Permit Number: 041129

has permission to Single Family Home w/ kitchen garage

AT 110 Ledgewood St P.I 087 E002001

From: Eric <eric@whittenarchitects.com>
To: <jmb@portlandmaine.gov>
Date: 10/14/2004 1:22:50 PM
Subject: Somers Residence-Peaks Island (Permit Add)

SECOND FLOOR PLAN

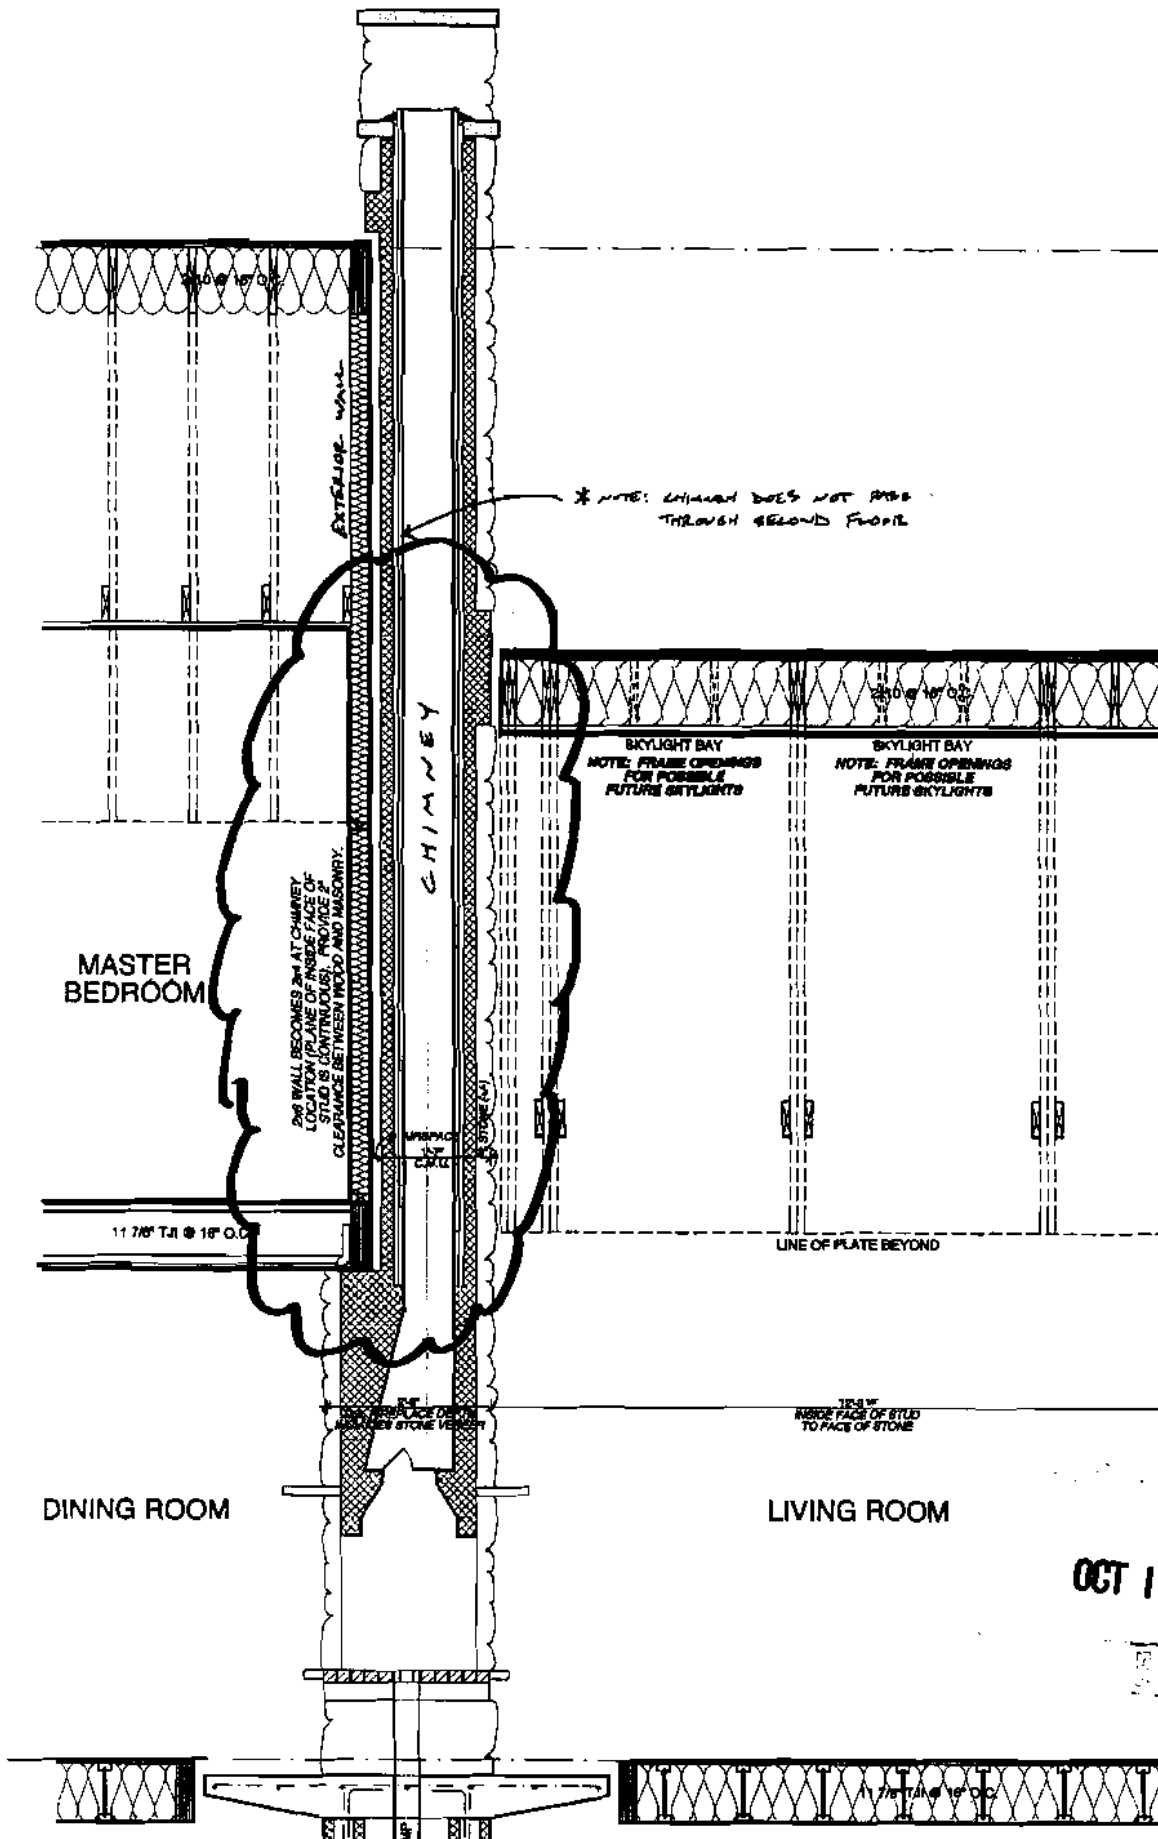
2. Chimney: the chimney will not pass through the interior spaces of the upper level. It emerges through the roof of the Living Room and runs alongside the exterior wall of the master bedroom. We are maintaining the 2" required airspace throughout. Please refer to sheets 2 and 2A in the pdf.

* NOTE: CHIMNEY DOES NOT PASS THROUGH SECOND FLOOR

2x6 WALL BECOMES 2x4 AT CHIMNEY LOCATION (PLANE OF INSIDE FACE OF STUDS IS CONTINUOUS) AND MAINTAINS CLEARANCE BETWEEN TRUSS AND MASONRY.

SOMERS 110 LSGOEWOOD ST - PEARLS ISLAND, N.H.
 DATE: 2.11.04

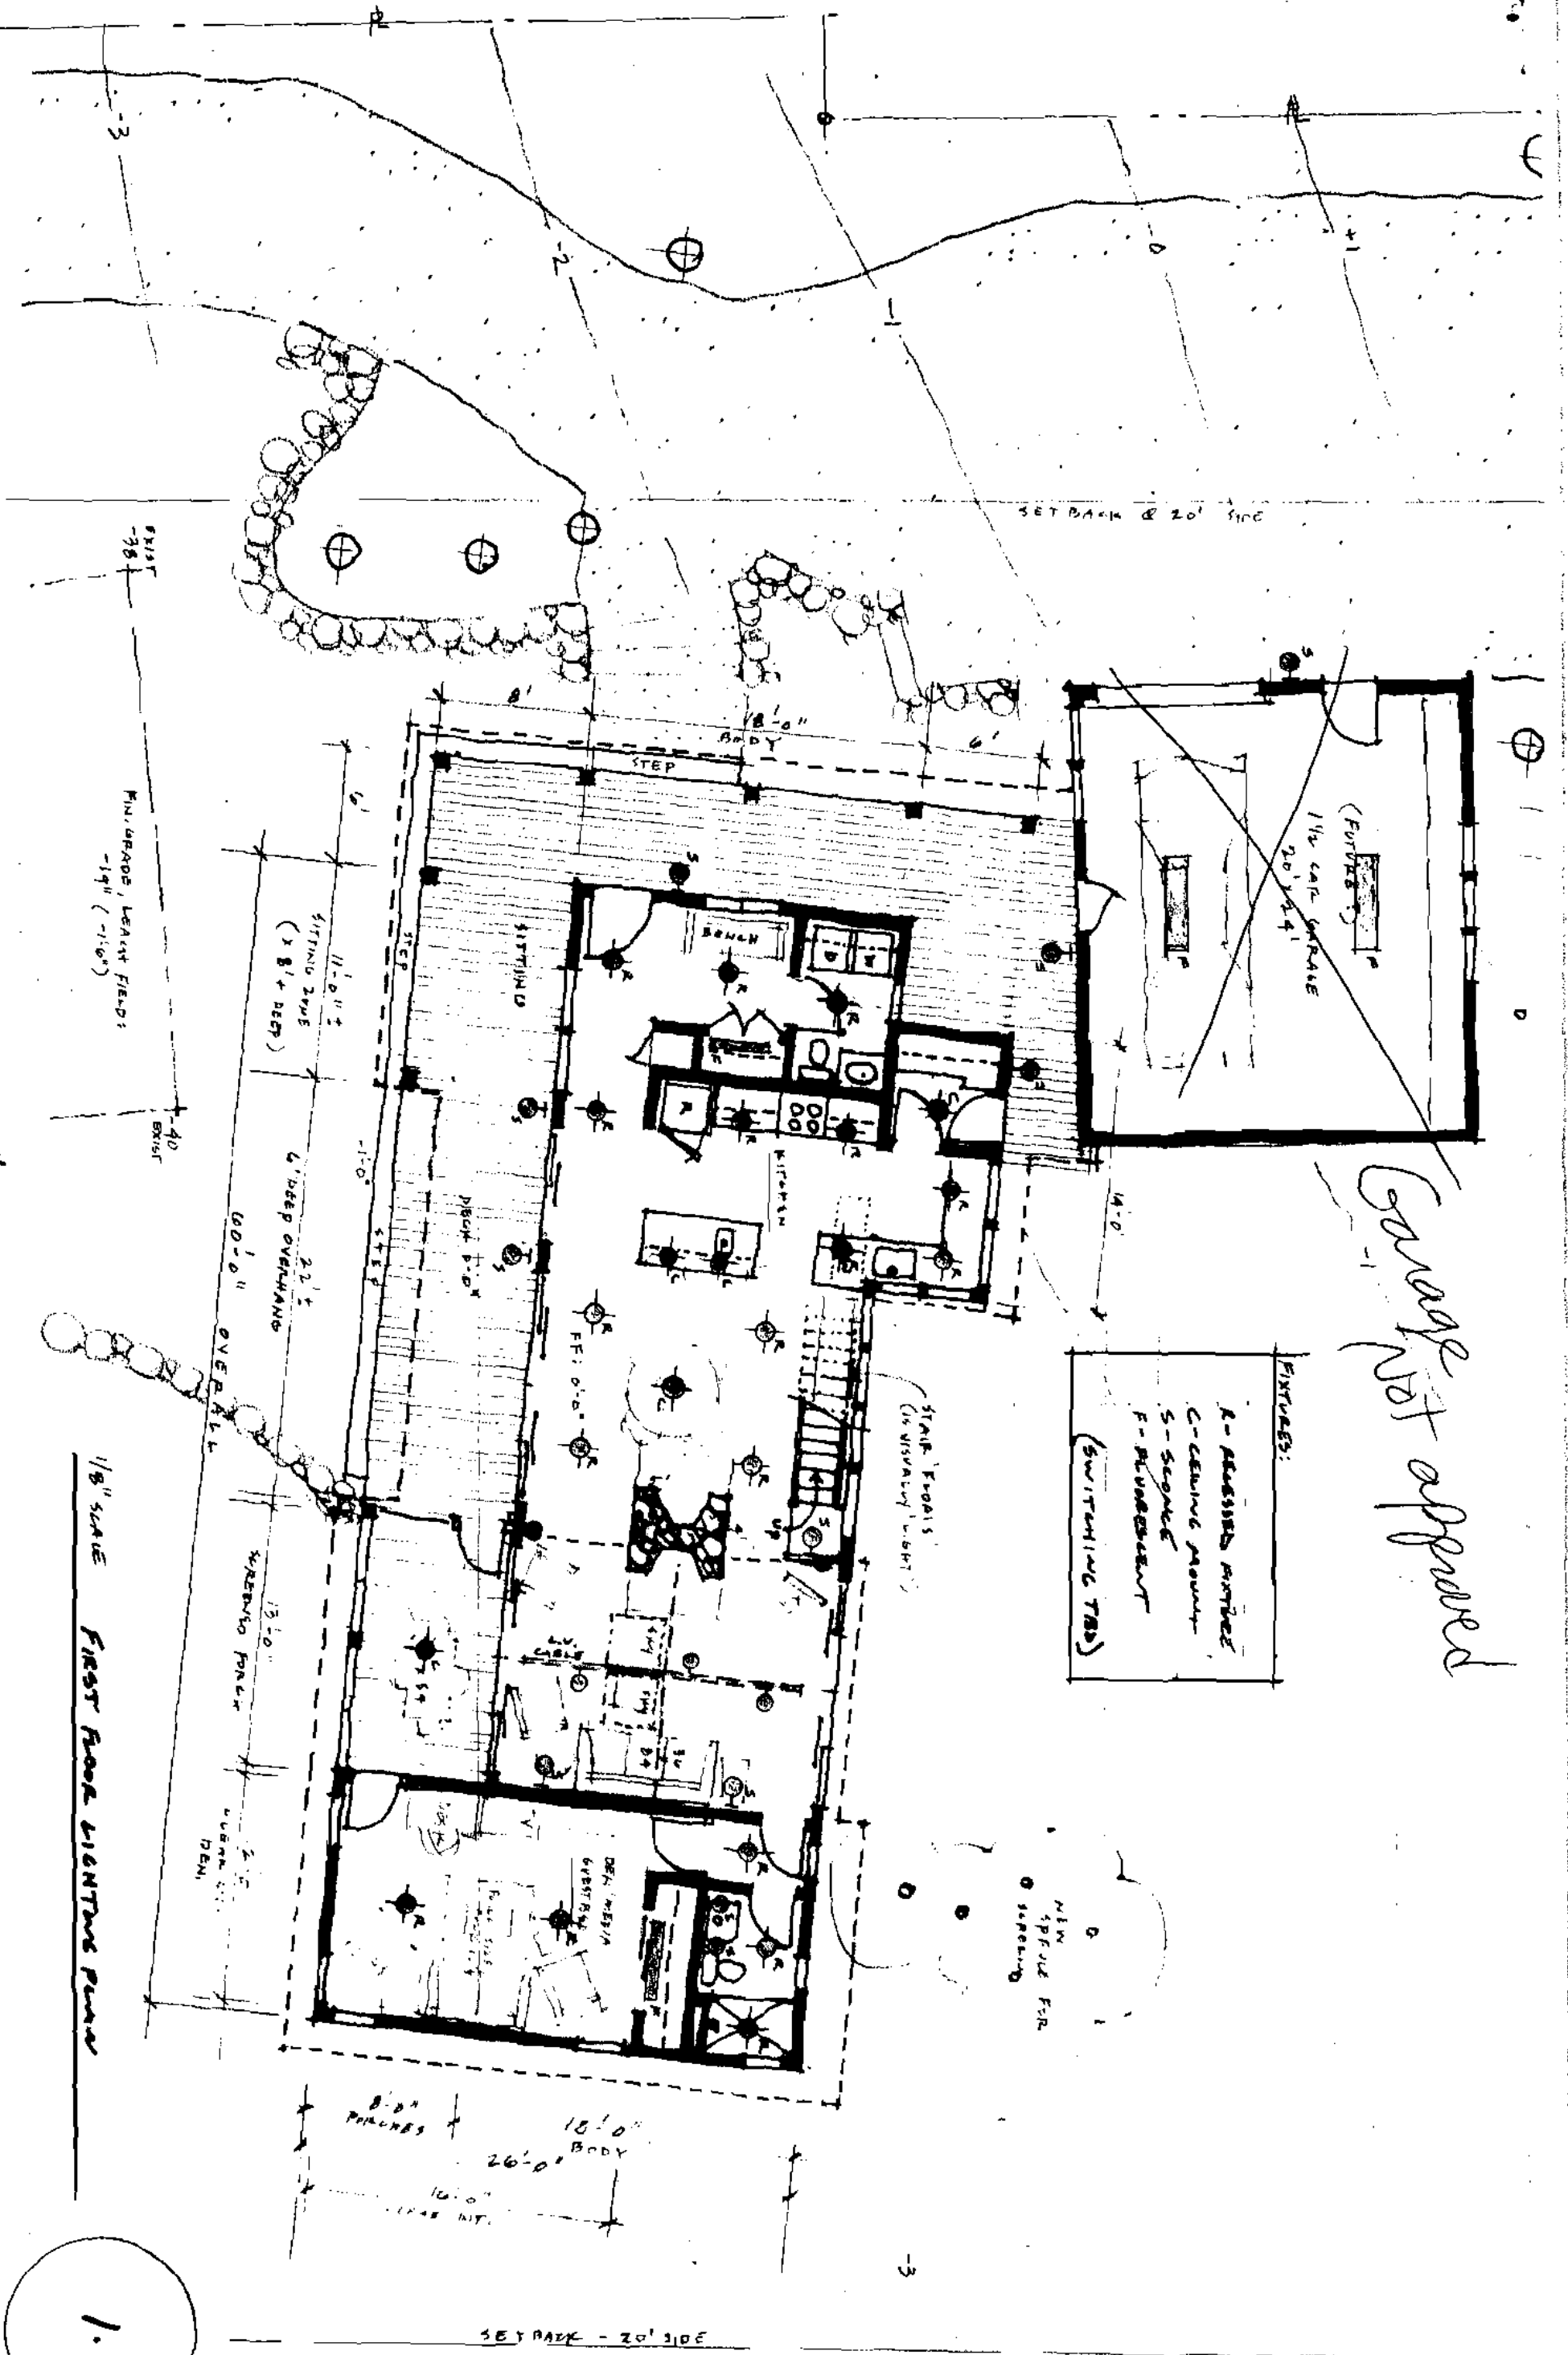
Garage not approved
